Type II Staff Report and Decision
Notice to Parties of Record

Project Name: 82nd Street Apartments

Case Number: PSR-2019-00122

Type II Site Plan and Environmental Review
Staff Report and Decision

SHEET NO.
C020

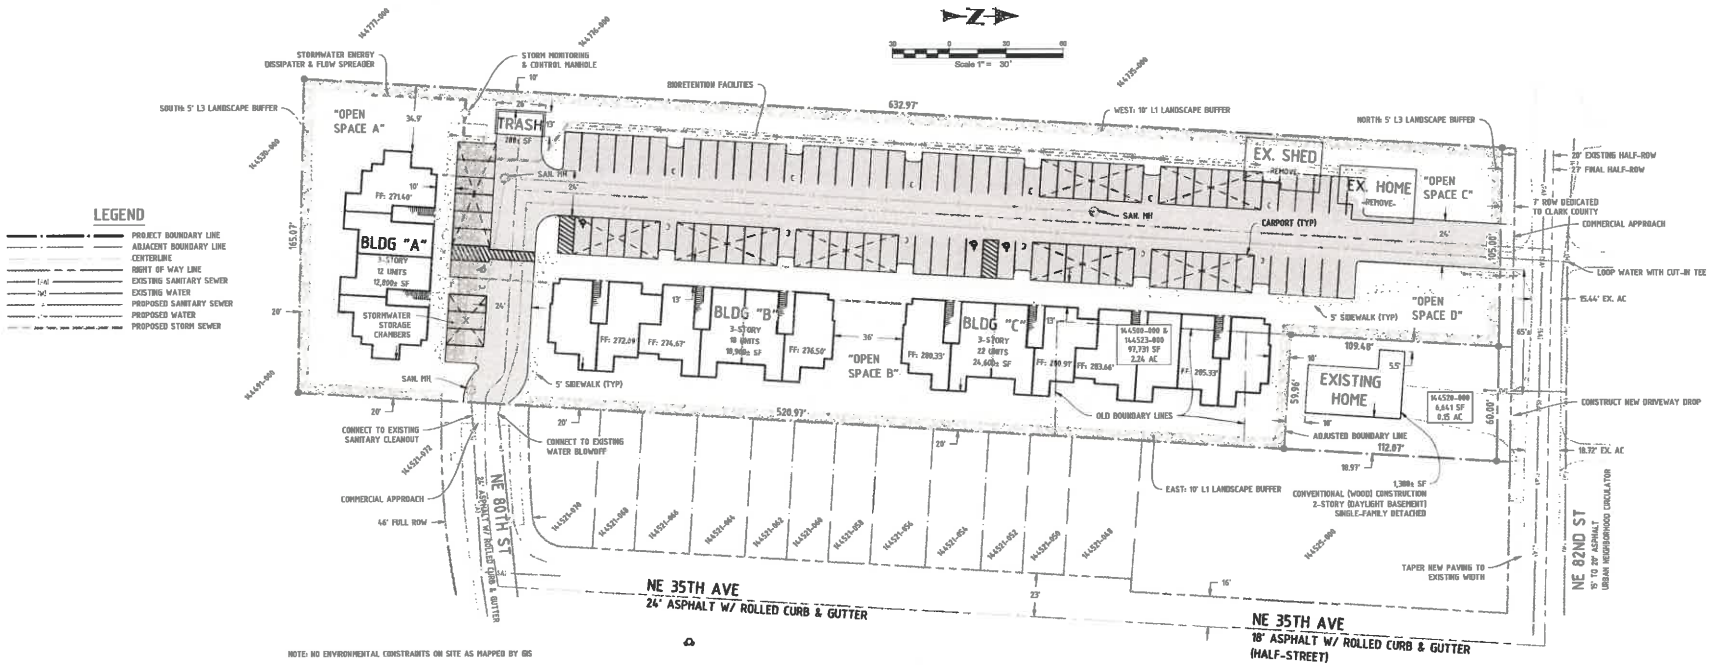
landscaping (for the apartment site only) equates to 19,546sf. Site statistics data provided on site plan indicates that a minimum of .91acres (39,640sf) of landscaped area is provided with this development, which meets this standard. However, site statistics shall be updated on the plans to differentiate landscaping provided for the apartments from the single-family lot. [See Condition A-1.g]

indicates a 5-foot landscape strip along NE 82nd Street, which does not meet minimum standards. Therefore, prior to final site plan approval, the landscape plan shall be revised to denote a 10-foot wide buffer along NE 82nd Street, planted to the L2 standard pursuant to Section 40.320.010(B)(2). [See Condition A-2.b]

A parking lot that provides between 101 and 150 parking spaces is required to provide a minimum of five (5) accessible parking spaces, one (1) of which is required to be van accessible. The applicant's site plan depicts four (4) accessible spaces, which does not meet this federal requirement. However, formal review for compliance with accessible standards, including parking and access will be performed at the time of civil plan approval and/or building permit review. [See Conditions A-3 & E-1]

Section 40.340.010(A)(10) requires that wheel stops or curbs shall be provided at least four (4) inches high and located three (3) feet back from the front of each perimeter parking space. The wheel stop/curb functions to prevent vehicles from extending over property lines or sidewalks, and to protect required landscaping from damage. Sheet C020 does not portray wheel stops as required. Therefore, prior to final site plan approval, the site plan shall be revised to include wheel stops, located three (3) feet back from the front of each visitor parking space in order to prevent vehicles from overhanging the sidewalk; or, the curb placement shall be pulled back an additional three (3) feet to accommodate the overhang. Any landscaped area that will be infringed upon by vehicle overhang cannot be included in overall site landscaped area calculations. [See Condition A-1.i]

b. The development shall remove a minimum of four (4) units from the site plan. [See Finding 3]

f. The site plan shall be revised to portray recreation facilities that meets the definition for "Recreation Space" put forth in CCC 40.100.070. [See Finding 4]

g. Site statistics on Sheet C020 shall be revised to differentiate landscaping provided on for the apartments from the single-family lot. [See Finding 5]

i. The site plan shall be revised to include wheel stops, located three (3) feet back from the front of each visitor parking space in order to prevent vehicles from overhanging the sidewalk; or, the curb placement shall be pulled back an additional three (3) feet to accommodate the overhang. Any landscaped area that will be infringed upon by vehicle overhang shall not be included in overall site landscaped area calculations. [See Finding 6]

b. The landscape plan shall be revised to denote a 10-foot wide buffer along NE 82nd Street, planted to the L2 standard, pursuant to CCC 40.320.010(B)(2). [See Finding 5]

c. The landscape plan shall be revised to denote a 10-foot wide buffer, planted to the L3 standard along the southerly boundary pursuant to CCC 40.320.010(B)(3). [See Finding 5]
